ADDENDUM & CORRIGENDUM NO. 01**Dated: May 20th, 2024****CONSTRUCTION OF SBP NEW OFFICE BUILDING D.I KHAN**

PROJECT: STATE BANK OF PAKISTAN
NEW OFFICE BUILDING AT DERA ISMAIL KHAN

TITLE: 12M HIGH POLE & LCP DETAIL

SCALE NTS.
DATE MAY., 2024
NO. SB-02-07052024

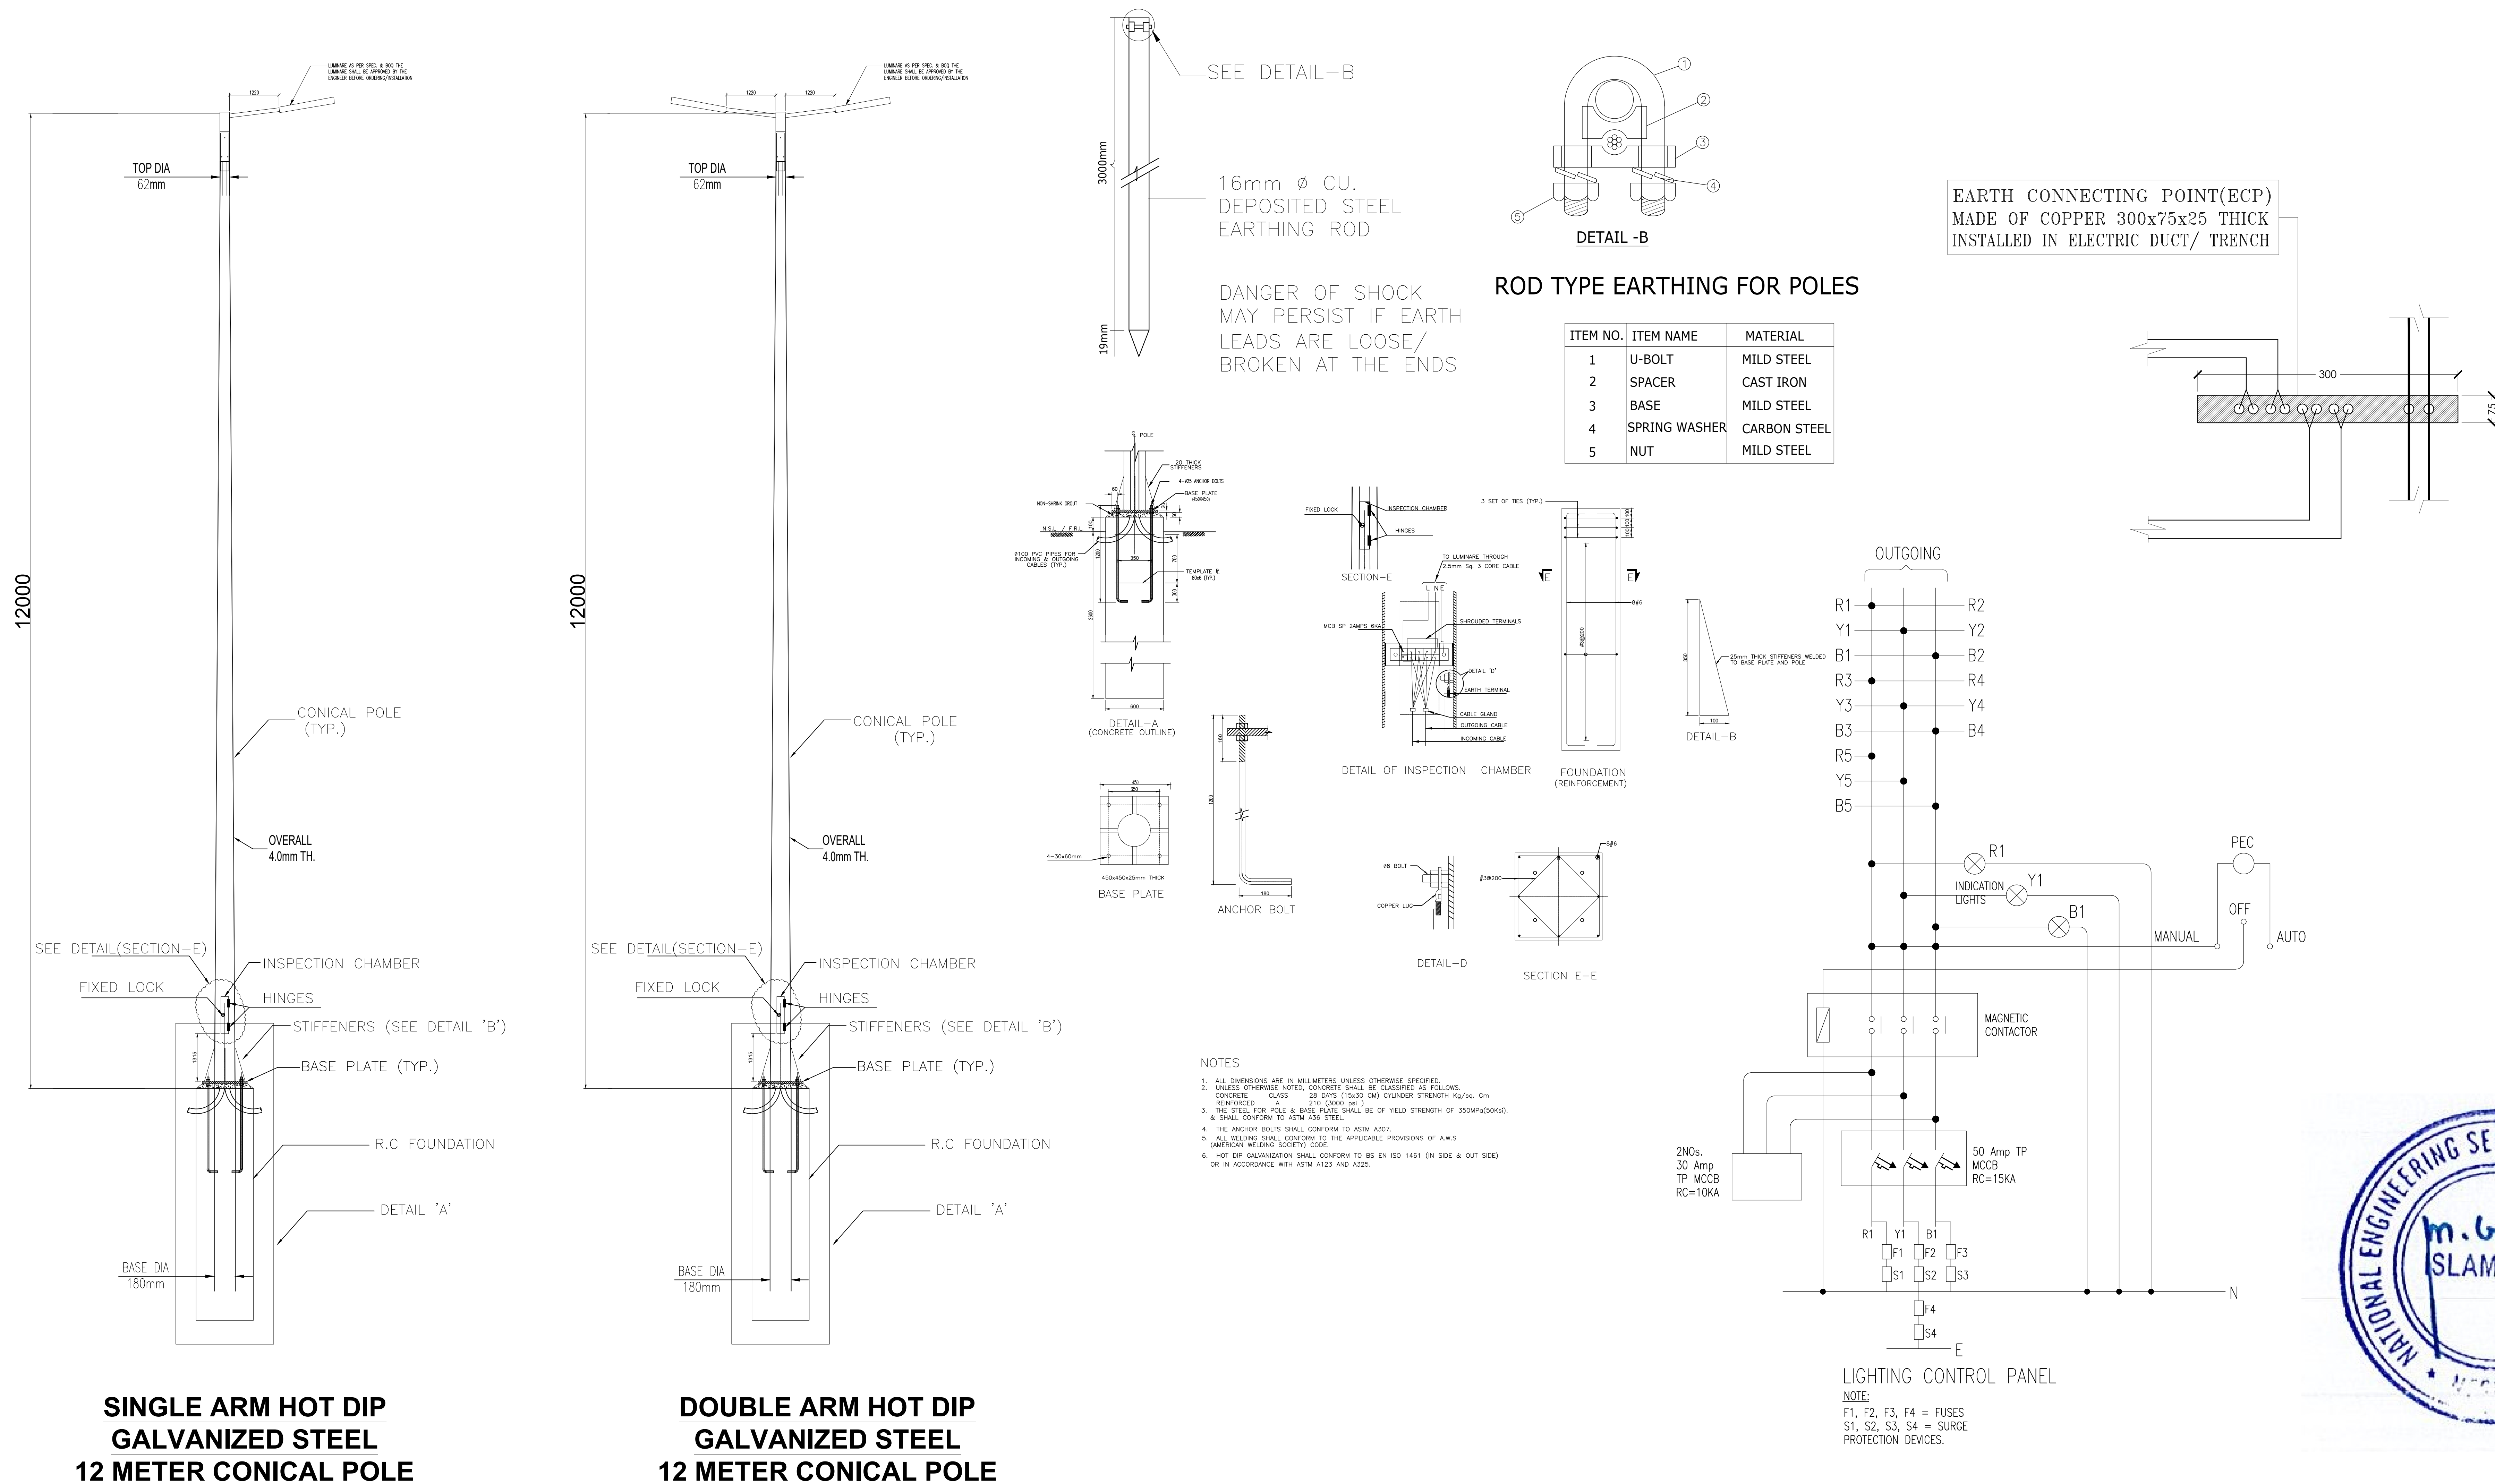
Sr #	Description / Reference / Clarifications Sought by Bidders / Corrections	<u>ADDENDUM & CORRIGENDUM</u>
10.	BOQ Item No. E-G-22,23 The detail Drawings for Light Poles are not provided	Details are attached as Annexure-A (Dwg # SB-02-07052024).
11.	BOQ Item No E-L-01 The size and details for ECP which will be installed in the Earthing PIT are not provided	Details are attached as Annexure-A (Dwg # SB-02-07052024).
12.	BOQ Item No. E-L-02 The Detail/Size of Earth Connection Point is not provided.	Details are attached as Annexure-A (Dwg # SB-02-07052024).
